Professor Hulsey's Interim Report Undercuts NIST WTC 7 Study

Prepared for the September 27, 2017 9/11 Truth and Other Deep State Crimes Teleconference

Wayne H. Coste, PE Truth Outreach, Inc.

Video vs. NIST WTC7 collapse animation comparison

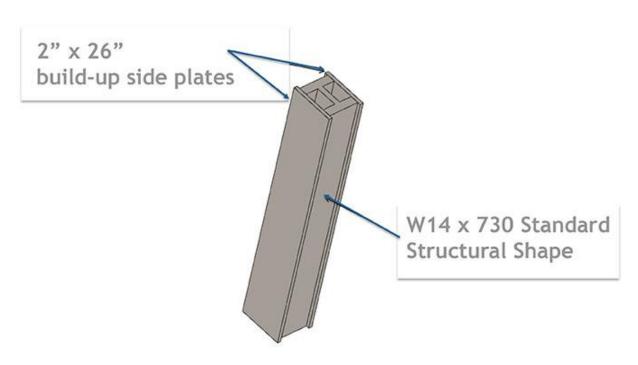
- He then reviews the NIST animated visualizations of their progressive collapse
 - Describes how the difference in the modeling of the connections (detailed vs. fixed pin) results in one side of the building behaving so differently than the other side
 - Asks the questions,
 - "Why is it so different on one side than the other?"

No exterior column deformation is evident in the actual collapse. Deformation is seen in the NIST model.

Plan View of girder A2001 moving across its bearing seat at column 79 due to thermal expansion of the beams framing into the girder from the east.

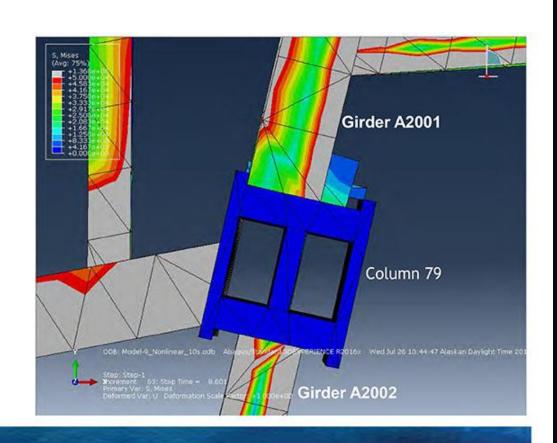
- With this construction
 - Bearing seat that would have restrained the motion of the girder (A-2001)
 - NIST said girder was pushed off of its seat
 - Thus initiating the progressive collapse
 - NIST did not represent lip in their model and misrepresented the width of the bearing seat
 - Hulsey: "It is not possible to move the girder web beyond the seat as claimed by NIST."

Note: This picture illustrates that A2001 is trapped by the column side plate and it is not possible for it to move the girder web beyond the seat as claimed by NIST.

It appears that NIST did not examine the side plate influence on the restriction of movement by the girder.

WTC 7 (Framing for floor 13)

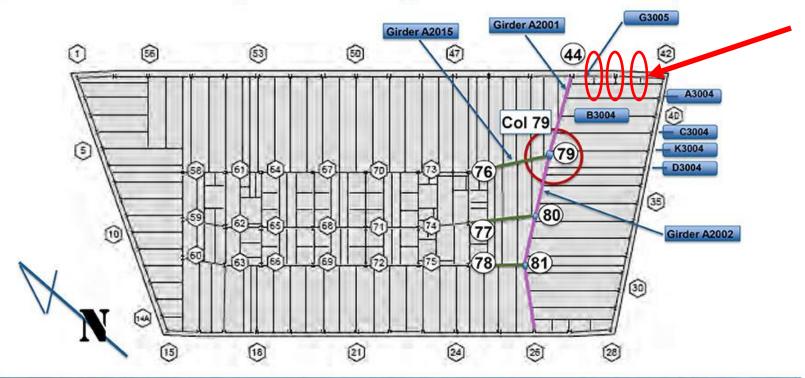
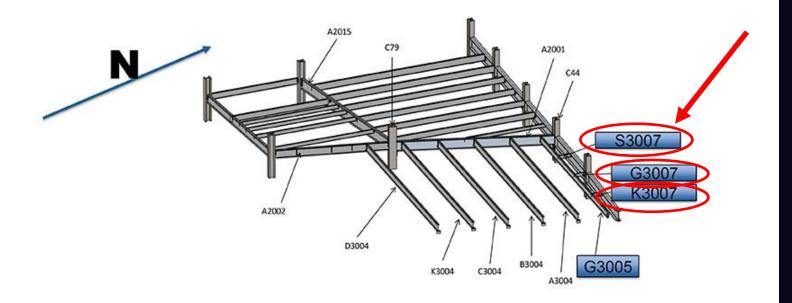
- NIST did not include three steel members in their analysis that provided lateral support to a critical beam (G-3005)
- The NIST collapse initiation hypothesis requires that these three members be ignored
- Hulsey, "[Our analysis] shows that the girder does not buckle when you have them in."

Lateral support beams \$3007, G3007 & K3007 were left off G3005 in the NIST analysis.

Section view of actual configuration of girder A2001 at its column 79 end from Frankel 1985 drawing 9114, showing its partial height web stiffeners.

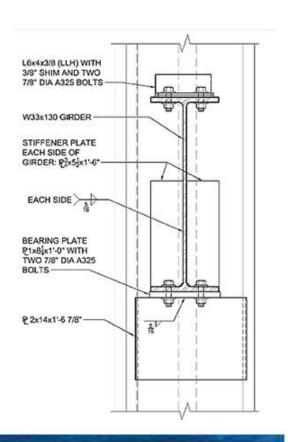
- NIST neglected the partial height web stiffeners, shown in the erection drawings
 - Omission of these web stiffeners was required for the NIST collapse initiation
- Hulsey:

"[Our UAF analysis] shows that the girder will not fail with the partial height web stiffeners installed."

UAF Modeling Results for Thermal Expansion

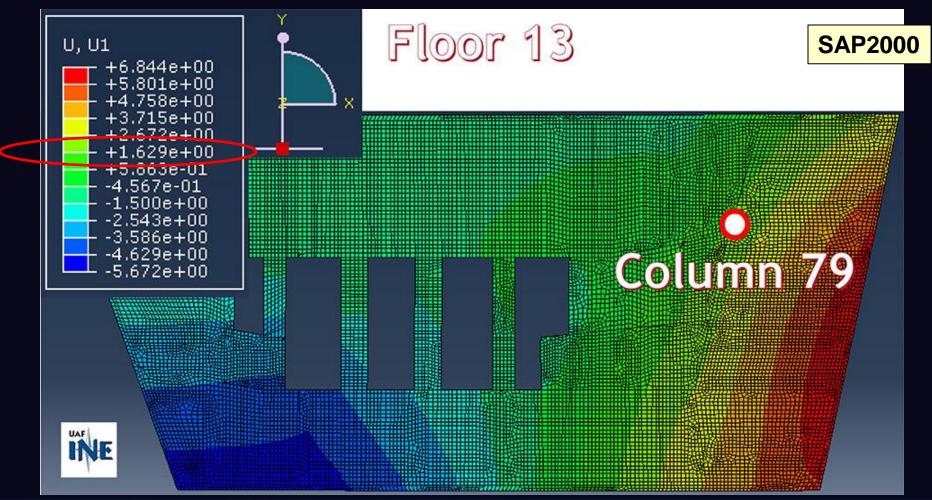
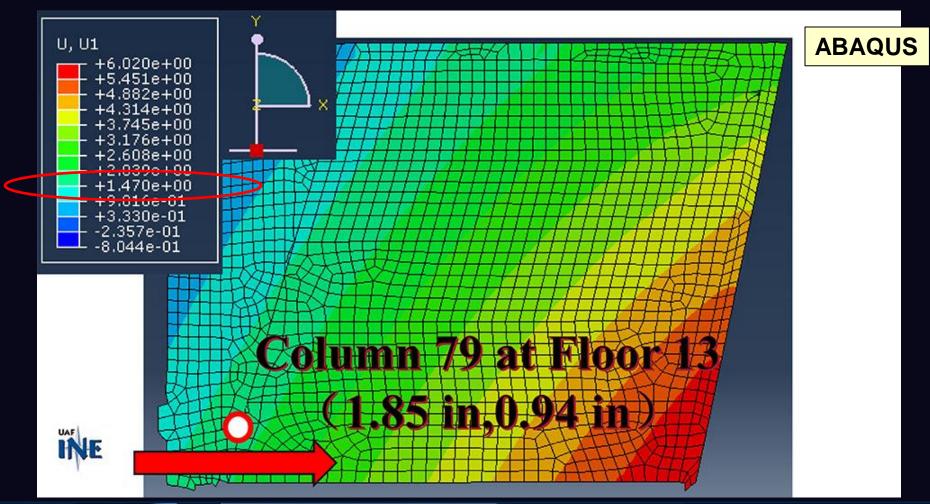
"So notice that our results in the SAP2000 model, [it shows] column 79 [moving] 1.92 inches to the right and;

1.85 inches to the right in the ABAQUS model.

NIST said the movement was 5.5 inches to the left; which they revised to 6.2 inches to the left."
